Economic Commission for Europe**Inland Transport Committee****World Forum for Harmonization of Vehicle Regulations****Working Party on Lighting and Light-Signalling****Eighty-third session**

**UN Regulation No. 48 (Installation of lighting and light-signalling devices):
Proposals for new series of amendments to UN Regulation No. 48****Revised proposal for a new [0x] series of amendments to UN
Regulation No. 48****Submitted by the Informal Working Group on Simplification of
Lighting and Light-Signalling Regulations***

The above limits and the initial aiming values are summarized in the diagram below.

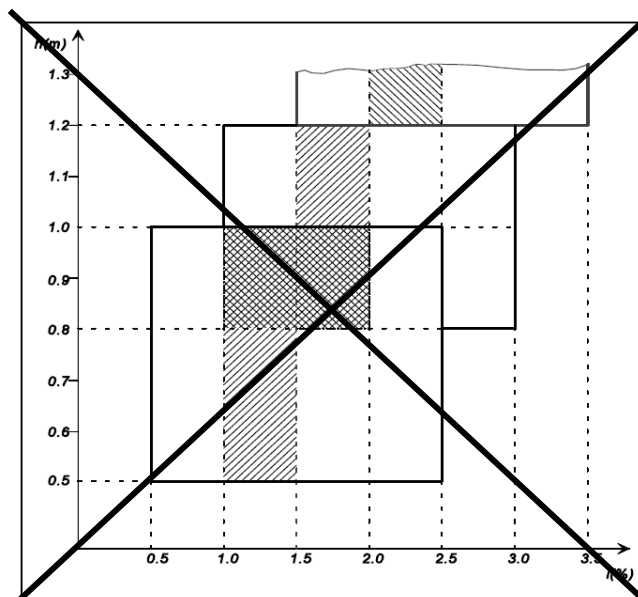
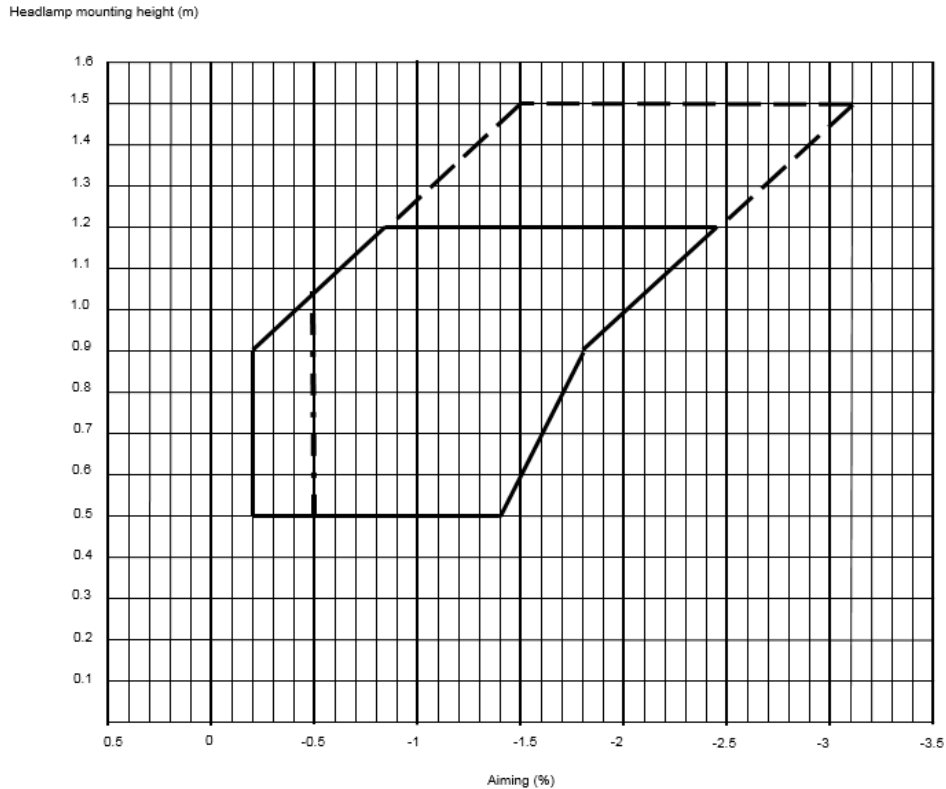
6.2.6.1.2. **Vertical inclination limits of the cut-off**

Depending on the mounting height in meters (h) of the lower edge of the apparent surface in the direction of the reference axis of the **passing beam (dipped-beam) headlamp**, measured on the unladen vehicles, the vertical inclination of the cut-off of the **passing beam (dipped-beam)**, **starting from the initial downward inclination value set by the vehicle manufacturer as prescribed in paragraph 6.2.6.1.1.**, shall under all the static conditions of Annex 5, remain between the following limits and the initial aiming shall have the following values: **under all the static loading conditions of Annex 5:**

<i>Mounting height h [m]</i>	<i>Upper inclination limit [per cent]</i>	<i>Lower inclination limit [per cent]</i>
$0.5 \leq h \leq 0.9$	-0.20	-1.40 to -1.80*
$0.9 < h \leq 1.2$	-0.20 to -0.85*	-1.80 to -2.45*
$1.2 < h \leq 1.5^{**}$	-0.85 to -1.50*	-2.45 to -3.10*

14. Paragraph 6.2.6.1.2. describes the new requirements for the vertical inclination limits of the cut-off, the provisions of which have been reorganised to improve readability. The vertical inclination values according to the installation height are presented in a table. A new diagram has been inserted providing an illustration of the requirements (aiming in per cent on the horizontal axis and headlamp mounting height in meters on the vertical axis).

16. The vertical line on the left was initially defined at 0 per cent and derived from the GTB study based on the ‘Klettwitz study’ (informal document GRE-71-32). However, some Contracting Parties were reluctant to have the horizontal cut-off with no downward inclination. At its seventy-eighth session, GRE experts decided to keep the previous vertical limit of - 0.2 per cent.

17. The inclined line on the left (starting from 0.9 m* in height), results from a mathematical calculation based on the position of the oncoming driver's eyes (at 0.94 m high) for headlamps up to a height of 1.2 m, measured at a distance of 25 m and with an initial aim of 1 per cent down. Using this calculation, it is possible to increase the inclination proportionally to the installation height and still guarantee that glare remains under control; the cut-off line will always stay under 0.94 m at 25 m distance (informal document VGL-10-03, sheet 13).

18. In addition, the line on the left side of the diagram was extended from a height of 1.2 m to 1.5 m in spite of the fact that, during the Klettwitz tests, no vehicles of categories M₂/M₃/N₂/N₃ were tested. This is the reason the lines above a height of 1.2 m are shown as dotted lines.

19. To cover all possible cases of a same type of vehicle (aiming tolerances / chassis deviation / cut-off-line stability / tyre deviation / full or empty tank / levelling device), a range of 1.6 per cent was agreed (see a survey of the International Organization of Motor Vehicle Manufacturers (OICA), informal document VGL-10-10) and used to define the right hand limit and the point (-1.8 / 0.9), based on line defined in item 16.

20. Starting from 0.9 m high, the range of 1.6 per cent is applied to define the line on the right side of the diagram and up to 1.5m.

21. On the right side, under 0.9 m high, there was a compromise to reduce the range progressively to 1.4 per cent at a height of 0.5 m (ECE/TRANS/WP.29/GRE/81, para. 10 and Annex II).

Model A

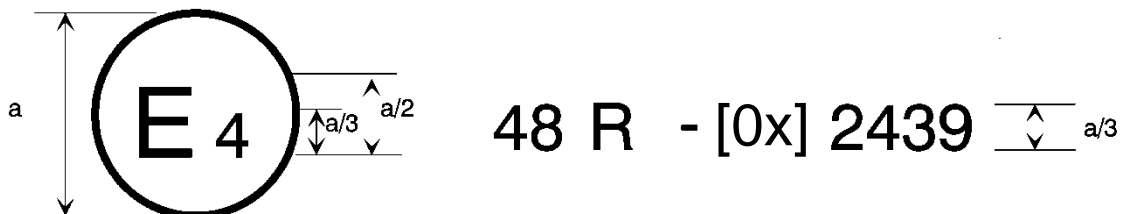
Annex 2, amend to read:

The above approval mark affixed to a vehicle shows that the vehicle type concerned has, with regard to the installation of lighting and light-signalling devices, been approved in the Netherlands (E 4) pursuant to UN Regulation No. 48 as amended by the [0x] series of amendments. The approval number indicates that the approval was granted in accordance with the requirements of UN Regulation No. 48 as amended by the [0x] series of amendments.

29. Some editorial corrections are made to Annex 2 (Arrangements of approval marks)

Model B

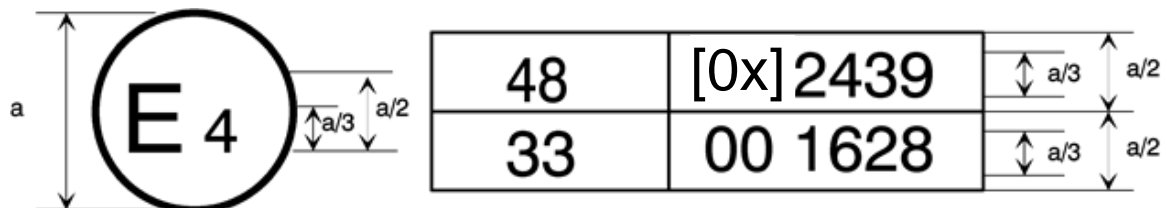
The above approval mark affixed to a vehicle shows that the vehicle type concerned has been approved in the Netherlands (E 4) pursuant to UN Regulation No. 48 as amended by the [0x] series of amendments and UN Regulation No. 33.¹ The approval number indicates that, at the dates when the respective approvals were given, UN Regulation No. 48 was amended by the 0x series of amendments and UN Regulation No. 33 was still in its original form.”

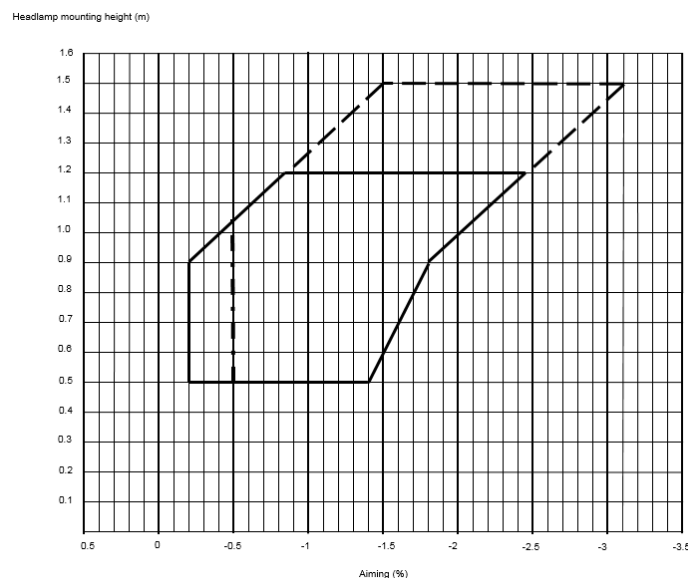
10. Paragraph 6.2.6.1.1., which provides the requirements for initial downward inclination, has been rearranged to improve readability. An additional requirement is introduced to limit the initial downward vertical inclination to the value of -0.5 per cent or less. The goal is to take into account the tolerances which have to be considered during the Periodical Technical Inspection (PTI) of headlamps. This topic was addressed during the IWG SLR Ad-hoc meeting on “Headlamp levelling”, held in Bonn on 28 November 2019 (the meeting minutes can be found in informal document Ad-hoc 04-Rev.1, based on presentation Ad-hoc 03).
